TECHNICAL BULLETIN

N117 – 2025.07

E75FPD

FLAT PANEL DOOR

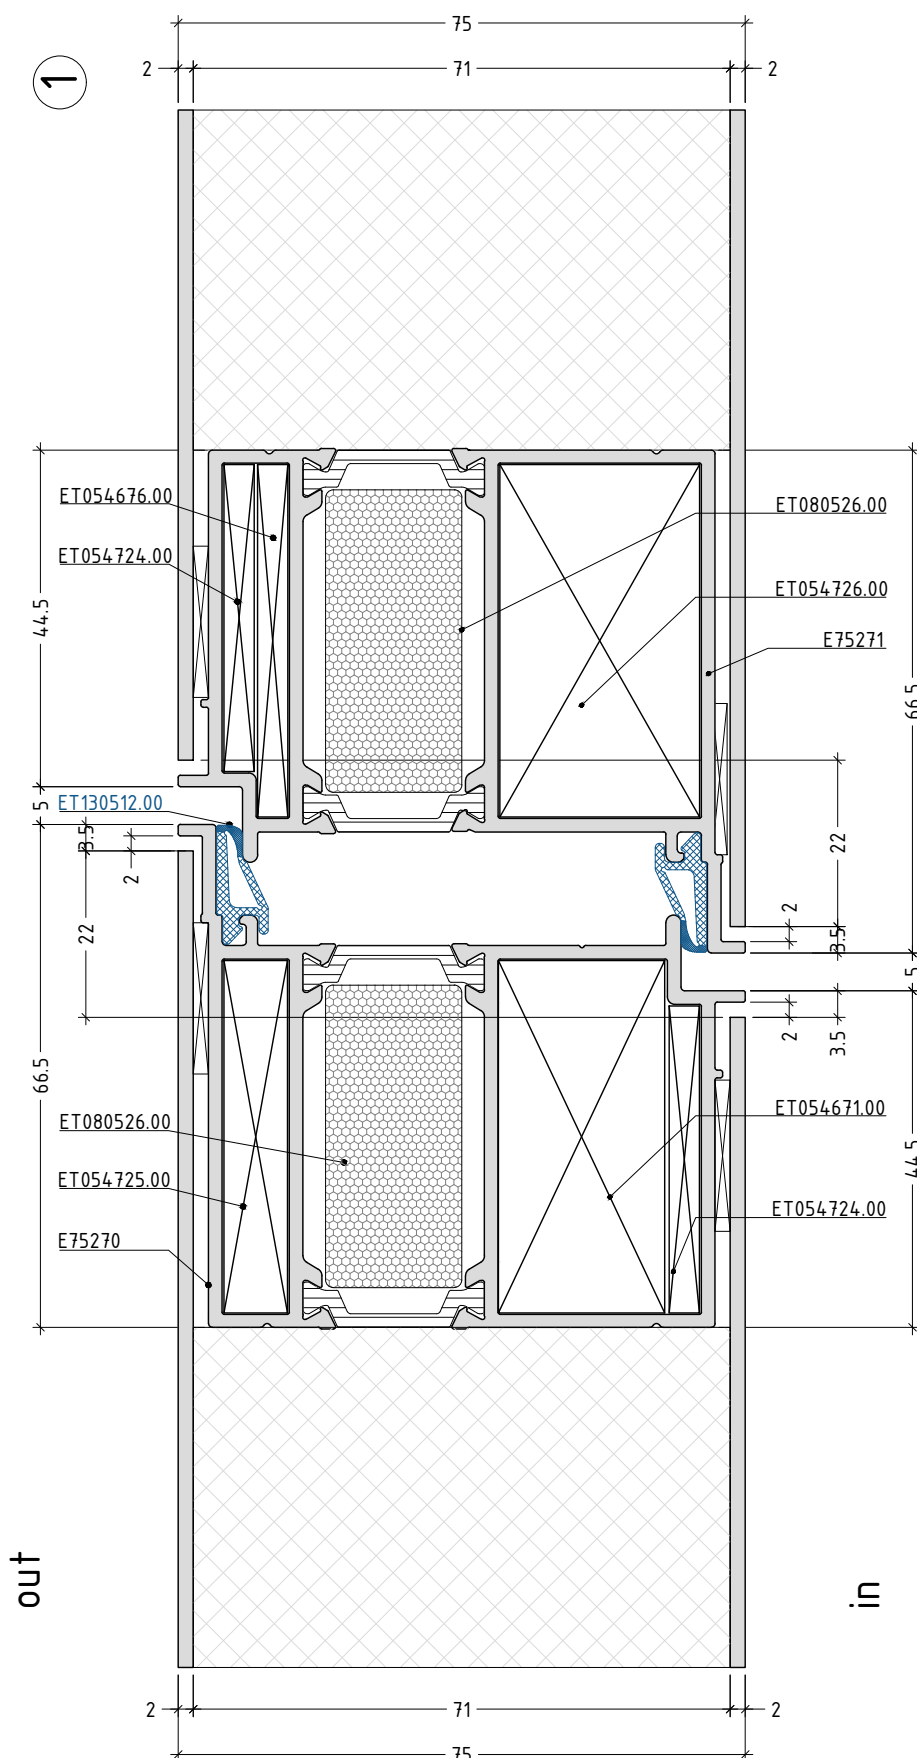
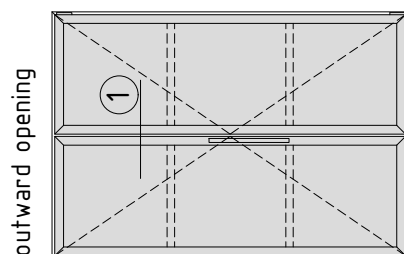
**New gasket ET130512.00 as a replacement for
ET130511.00**

outward opening

Gasket for E75FPD
As a replacement of ET130511.00

①

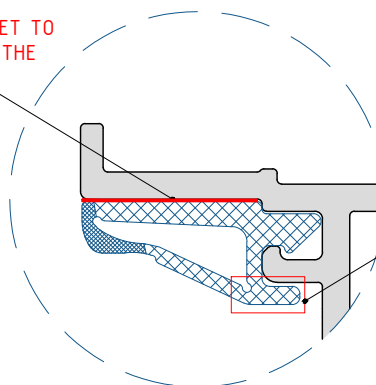
GLUE THE GASKET TO THE PROFILE IN THE HINGE AREA

PARTIAL CUTTING OF THE GASKET IN THE HINGE AREA
